# *City of Brisbane*

## *Planning Commission Agenda Report*

**SUBJECT:** **Parking Use Permit UP-1-20 and Grading Review EX-1-20; 130 Sierra Point Road;** R-1 Residential District; Use Permit to allow for nonconforming interior dimensions of a two-car garage and Grading Review for approximately 150 cubic yards of soil cut and export to accommodate a new single family dwelling on a 5,000 square-foot lot with a 33% slope; Wilson Yu, applicant and owner.

### **SUPPLEMENTAL REPORT**

# A101

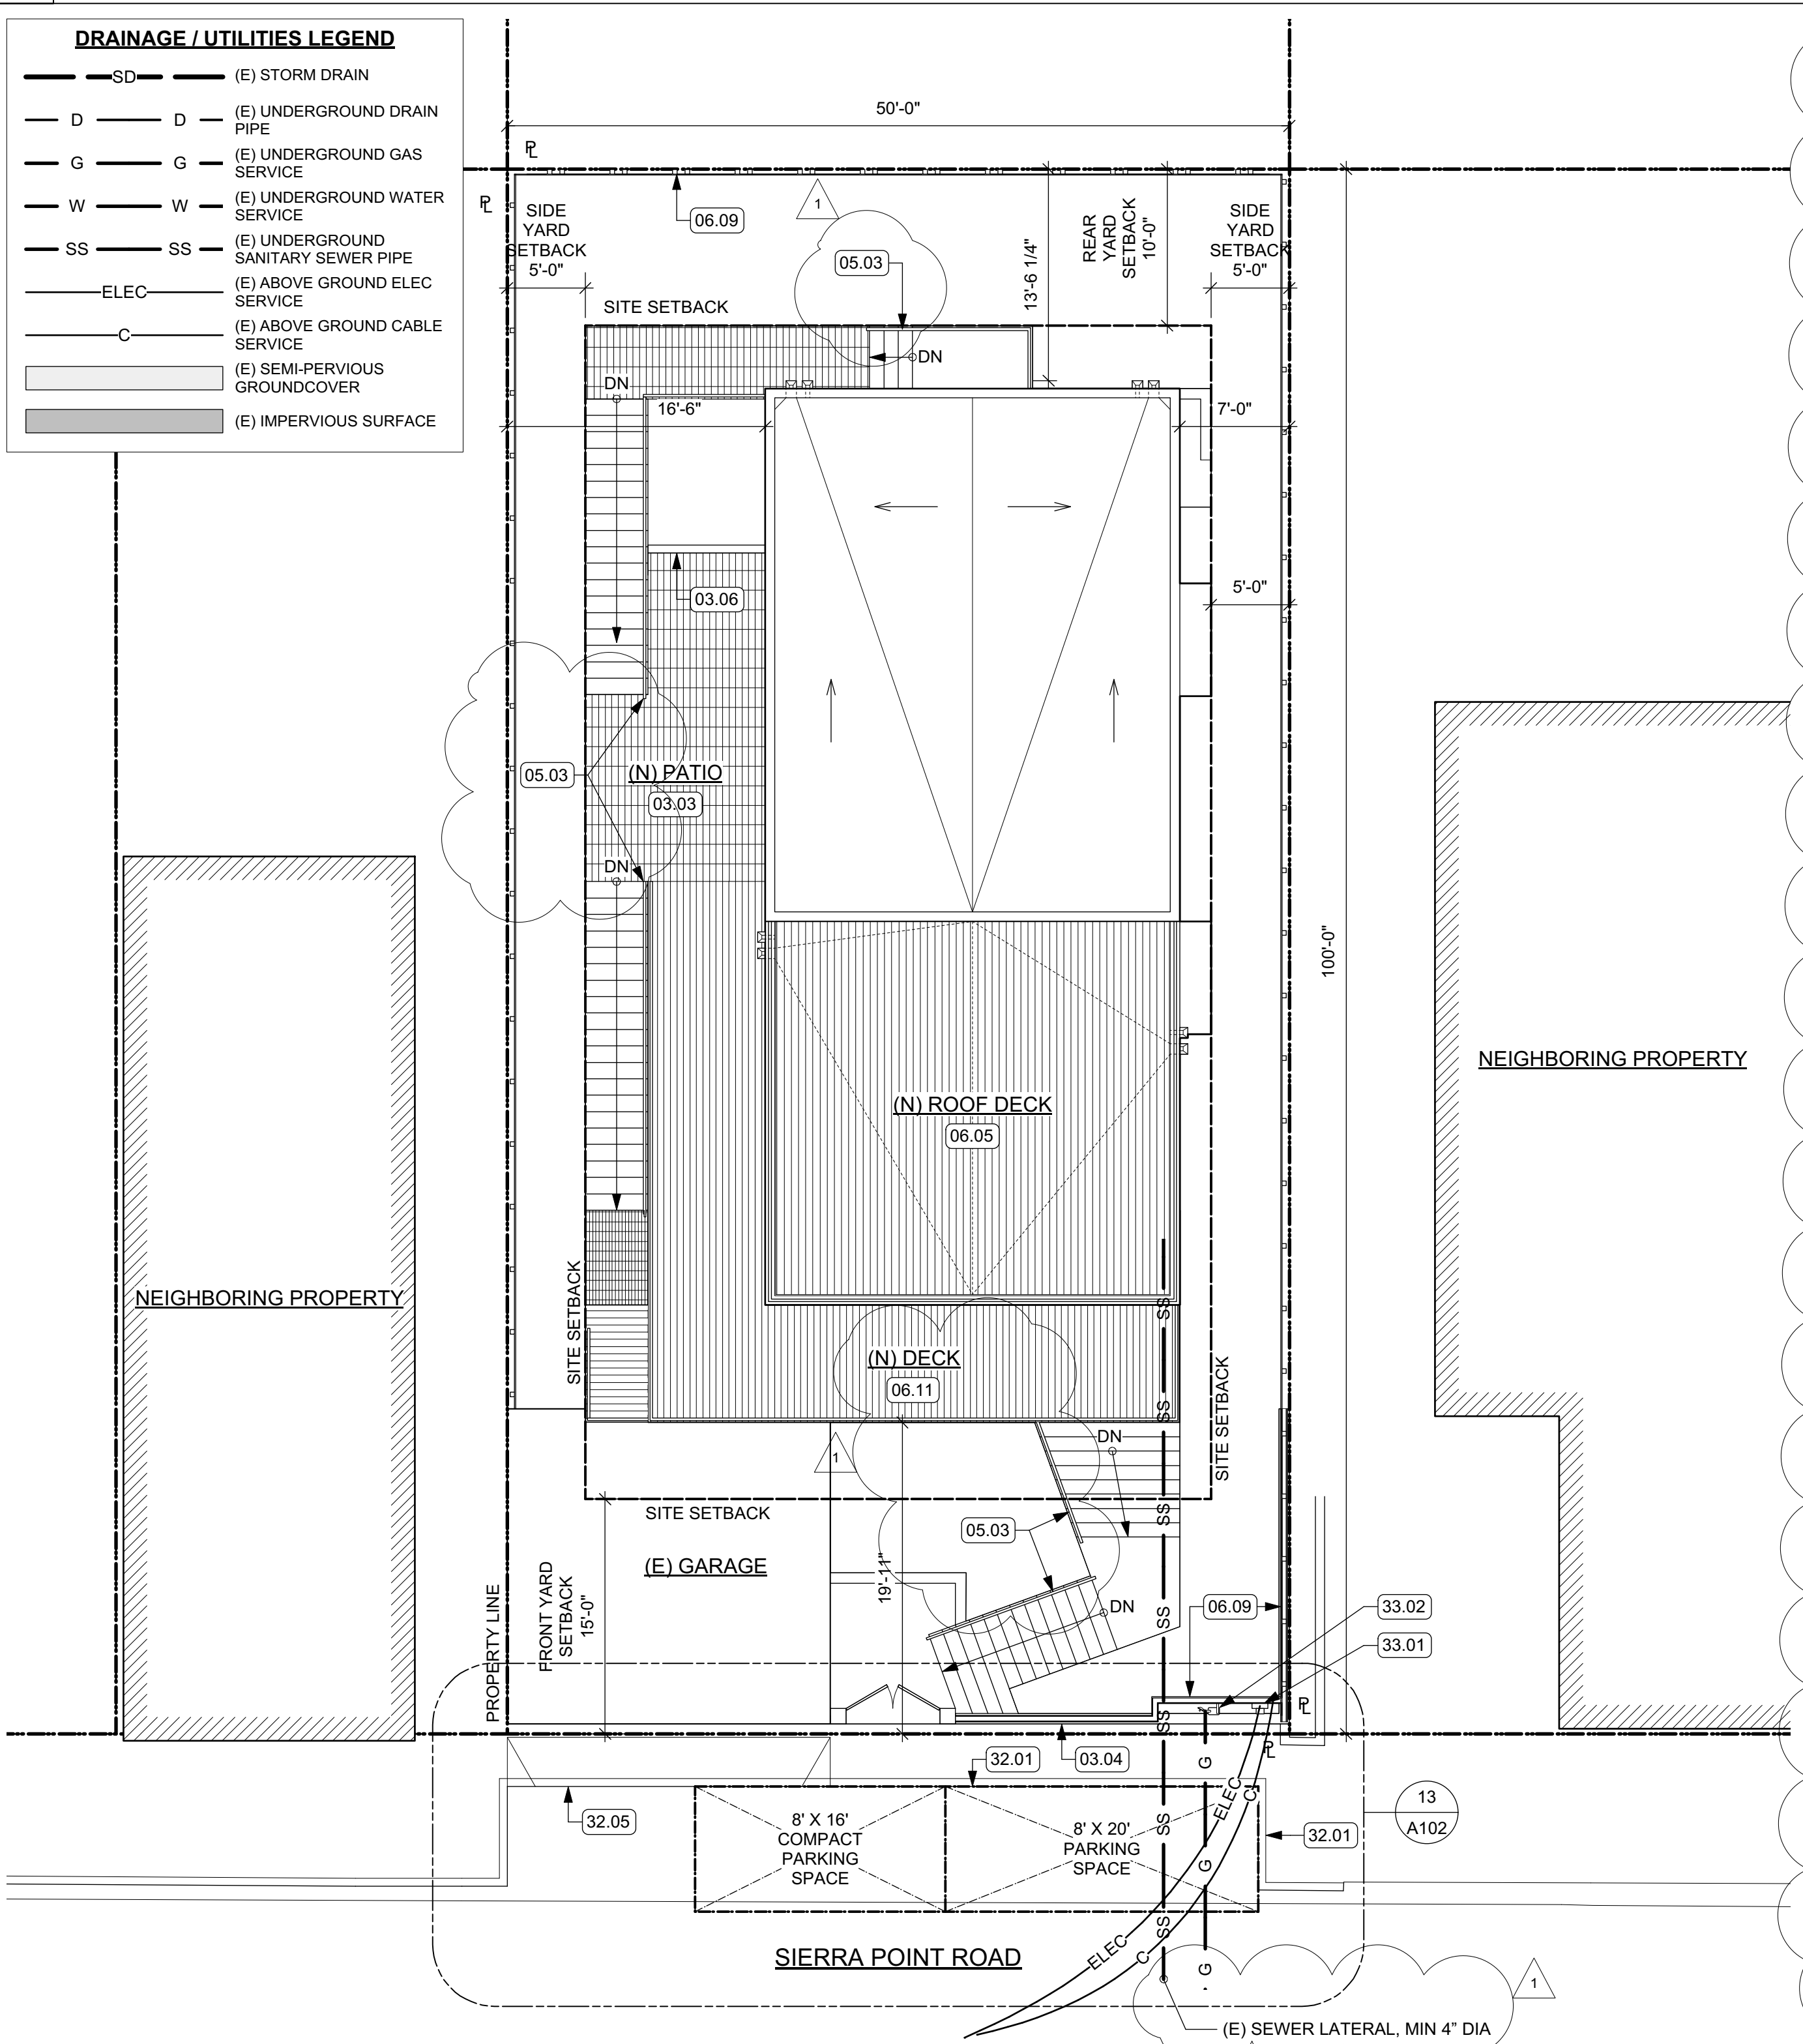
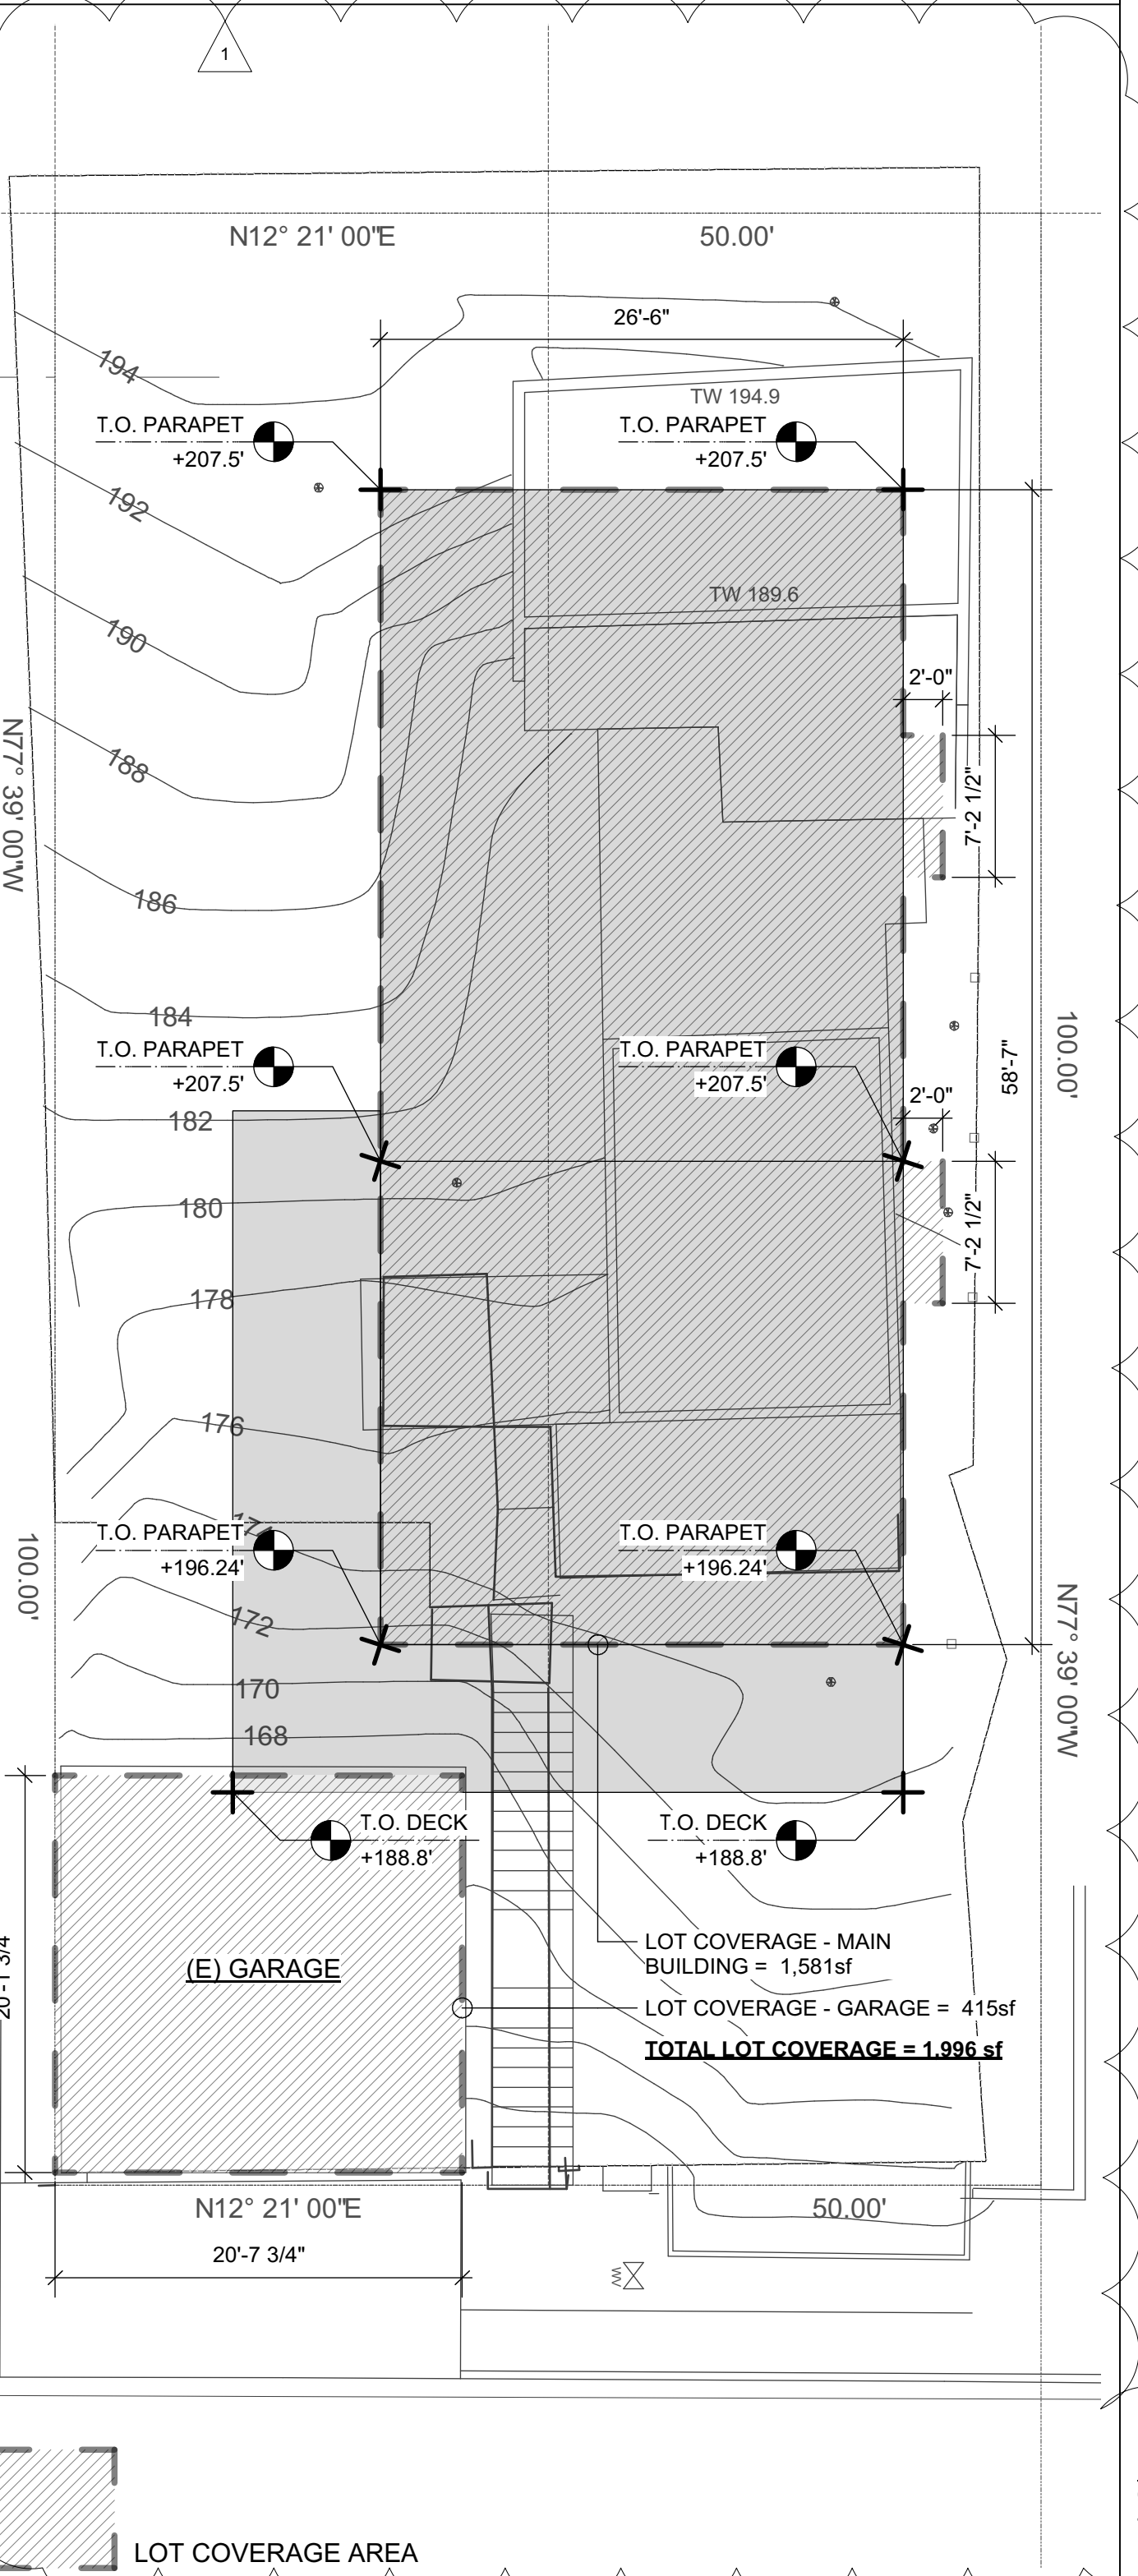
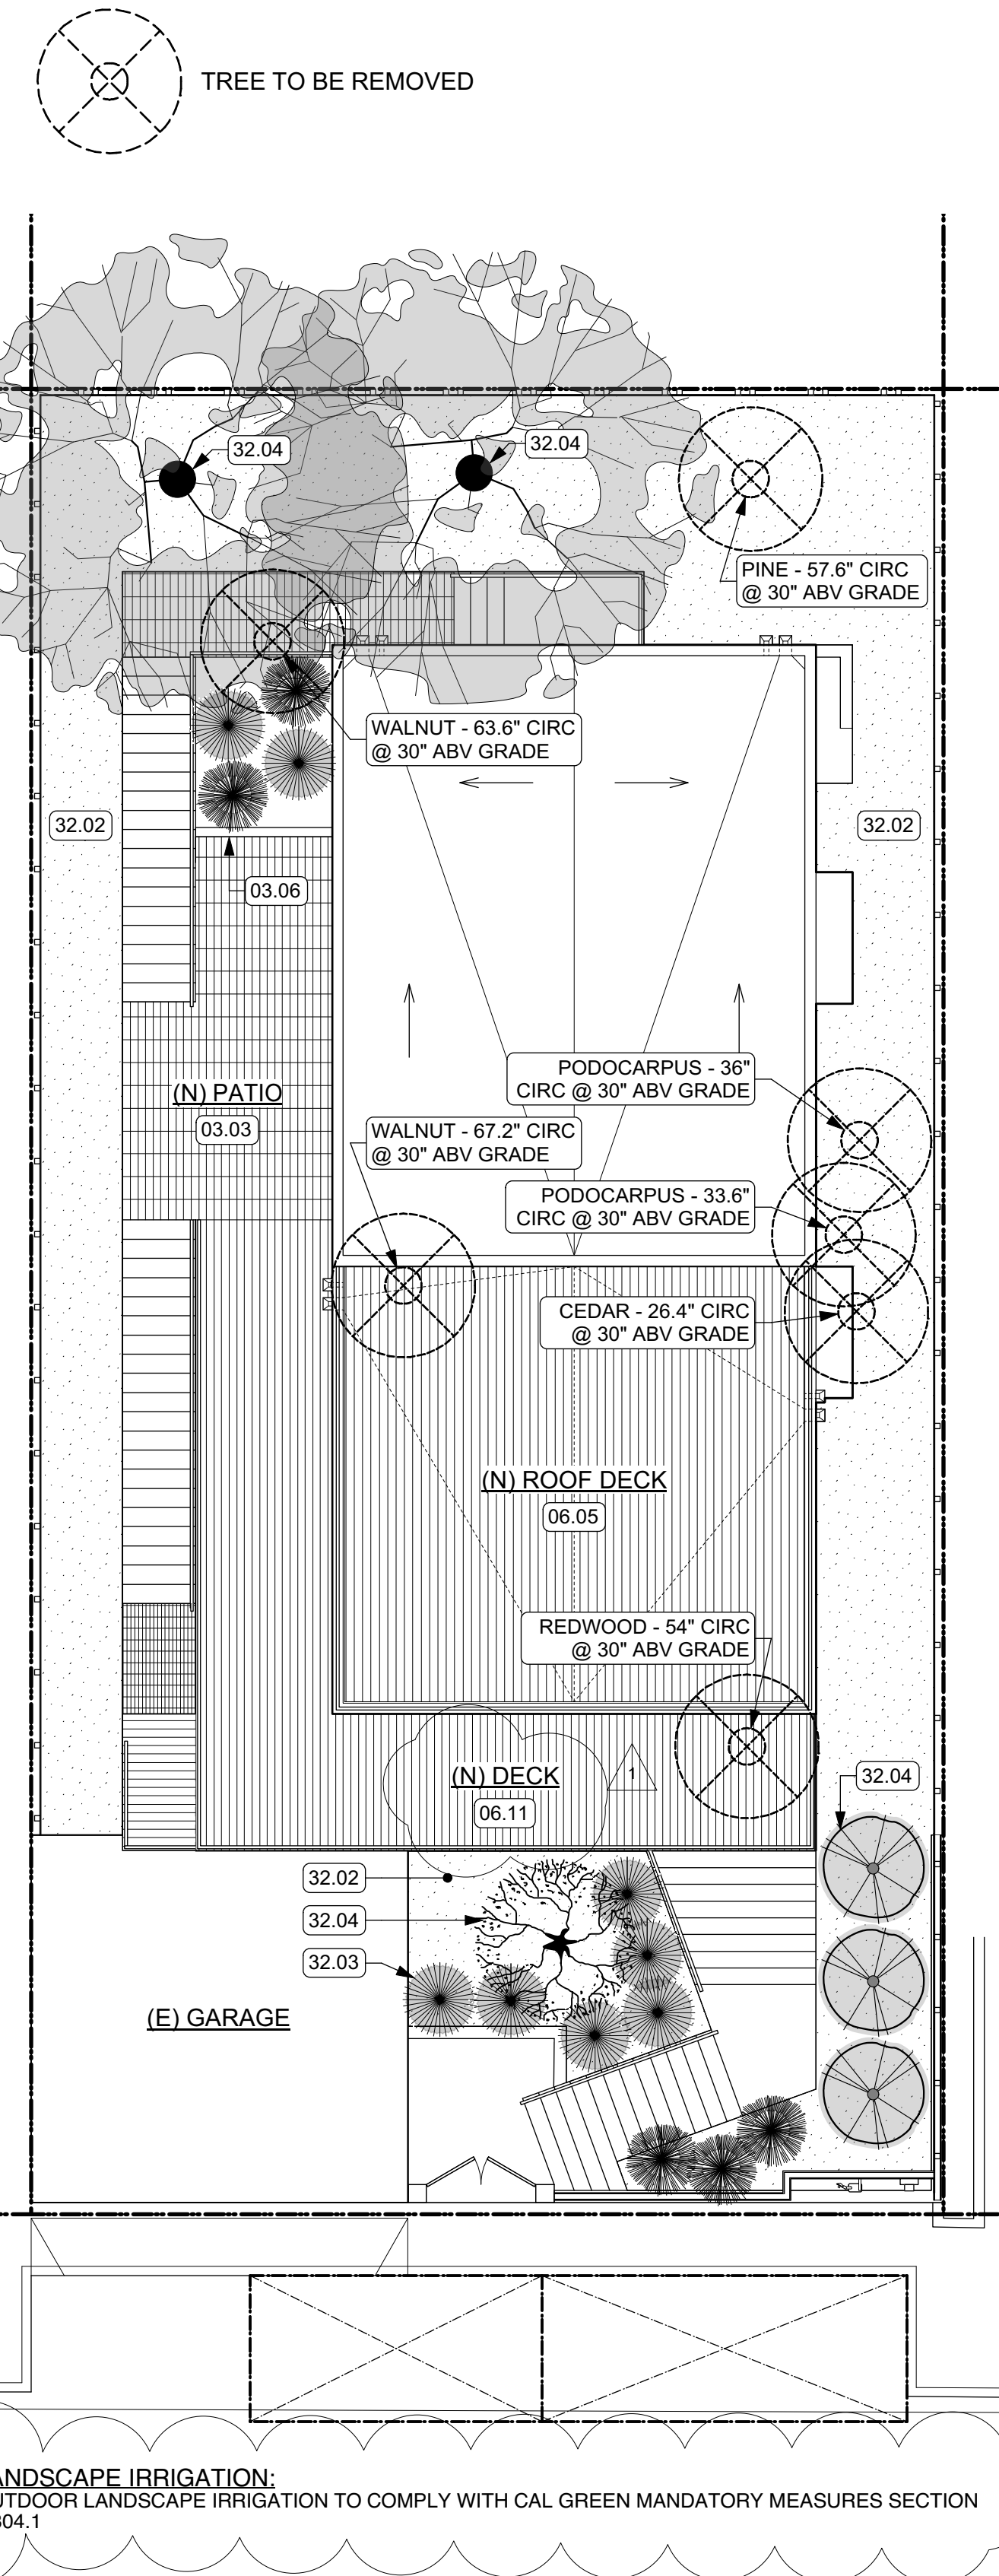
The project requires removal of five mature trees – two Walnut, two Podocarpus, and one Redwood – and one juvenile Cedar tree, which are located within the footprint or in close proximity to the new home (refer to Sheet C-2.1 of the applicant’s grading plans, Attachment E.i). A seventh (Pine) tree outside of the project footprint is proposed to be removed as well because it has been identified as dead by a certified arborist (refer to email correspondence from Joshua Rumbley, Attachment E.ii and photos 4-6, Attachment C). None of the seven trees are a protected species (refer to Sheet A101 of the applicant’s plans, Attachment E.i).
